**ADDENDUM NO. 2 TO PROJECT NO. 44770**

**CONSTRUCTION WORK, HVAC WORK, PLUMBING WORK, ELECTRIC WORK  
REHABILITATE BATHROOMS  
HIGHLAND RESIDENTIAL CENTER  
629 NORTH CHODIKEE LAKE ROAD  
HIGHLAND, NEW YORK 12528**

January 28, 2014

ADA-101

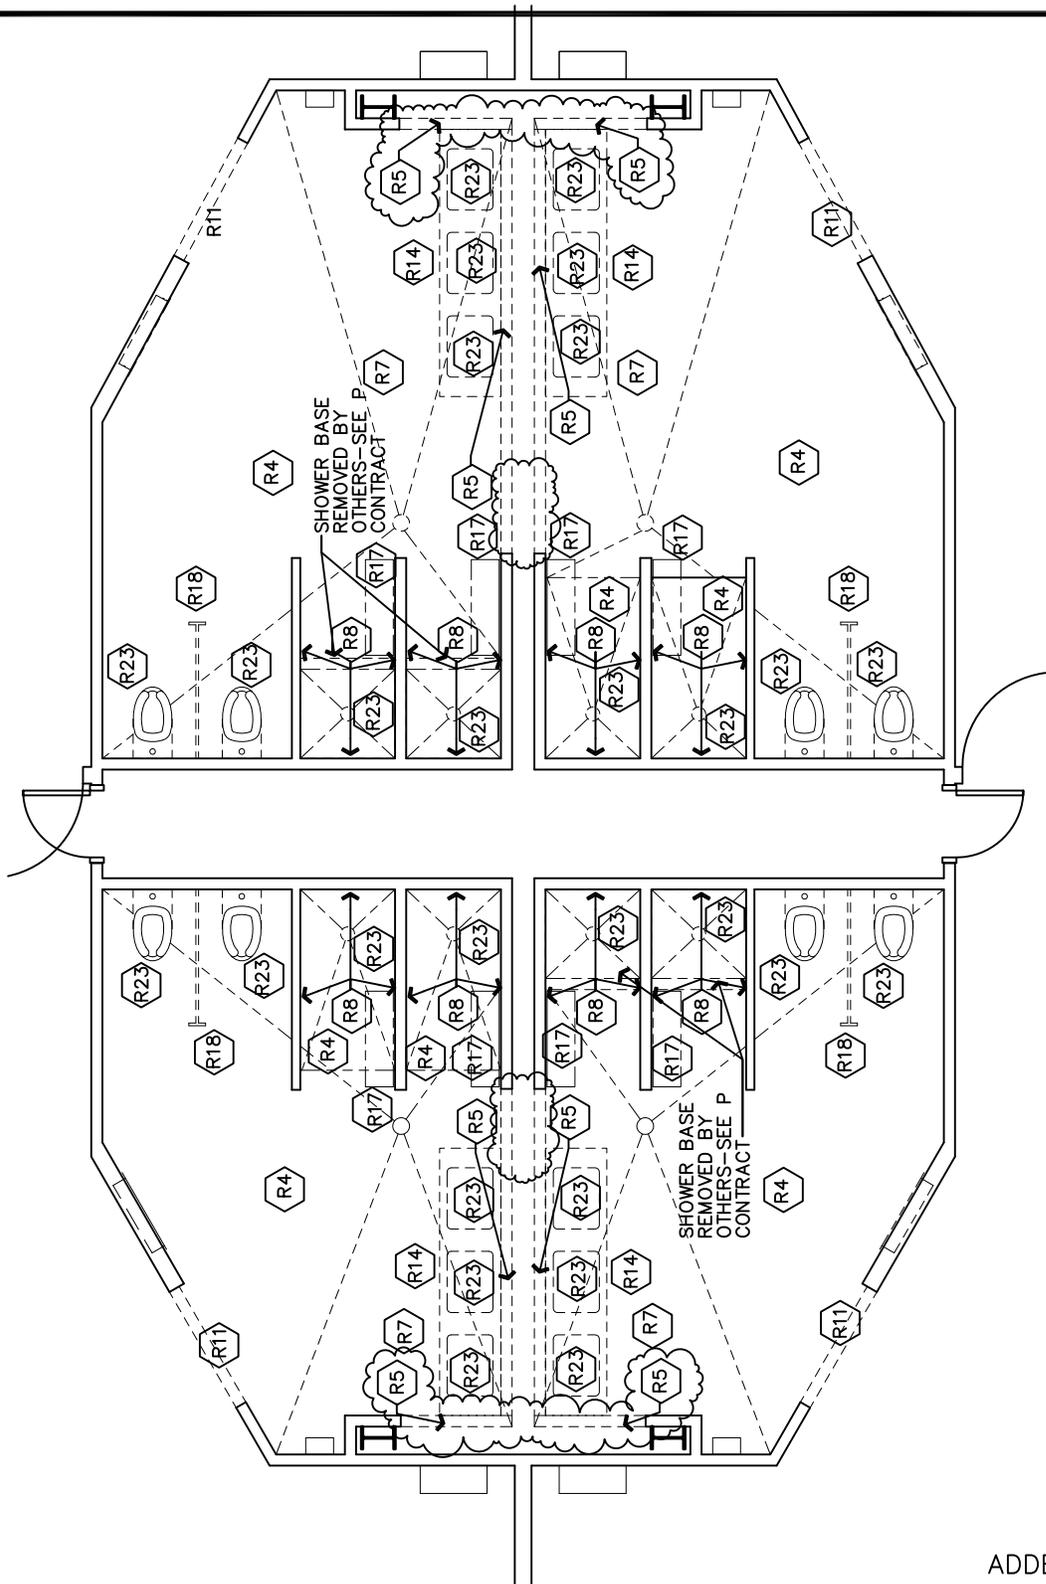
2. Drawing A-101:
  - a. Detail 2: Replace this detail with Addendum Drawings ADA-102 and ADA-103.
  - b. Detail 3: Replace this detail with Addendum Drawing ADA-101.
